Report Type: DA Access Report
Reference Number: 19260
Client: Mono Constructions
Site Address: 56 Beane Street, Gosford, NSW

ACCESS REPORT

This Access Compliance Report is to accompany a Development Application for the development proposed at 56 Beane Street, Gosford, NSW.

Unit 101

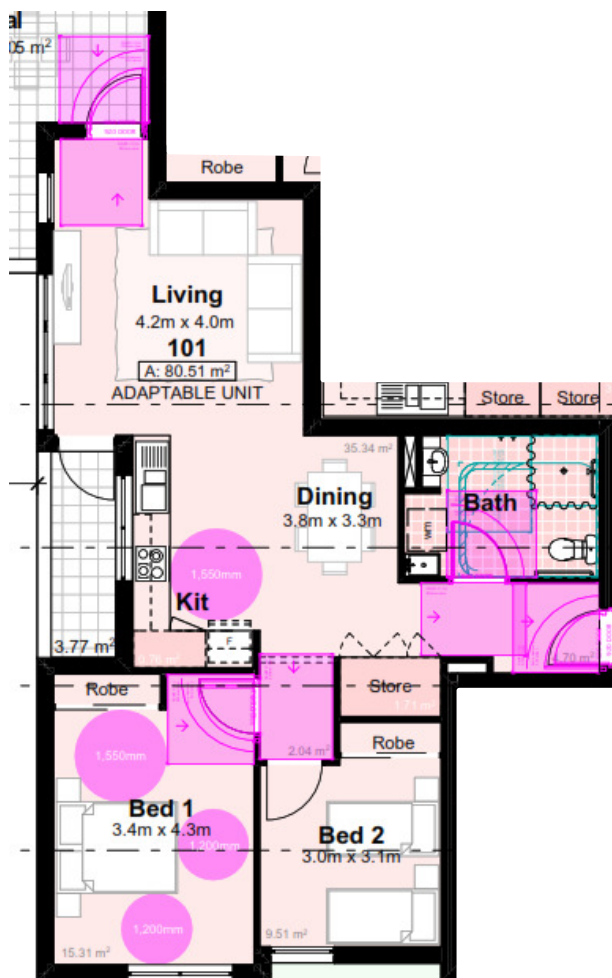
At DA stage there is insufficient information to certify compliance with the Standard, however, in accordance with the table below, the nominated units can comply with the spatial requirements of AS4299 for Adaptable Housing.

Unit 501, 601 and 701 typical

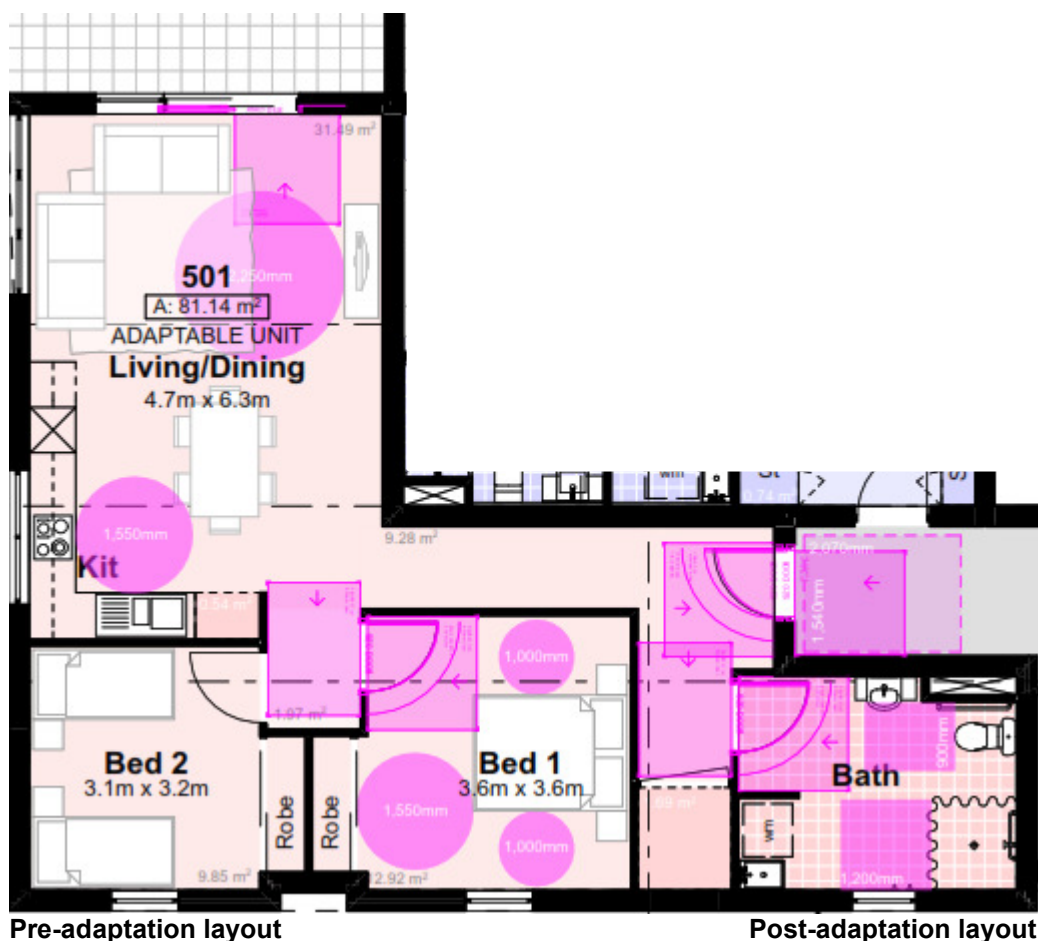
By incorporating the essential requirements listed Checklist below in the Specifications, the nominated Adaptable units can achieve full compliance with Adaptable House Class C
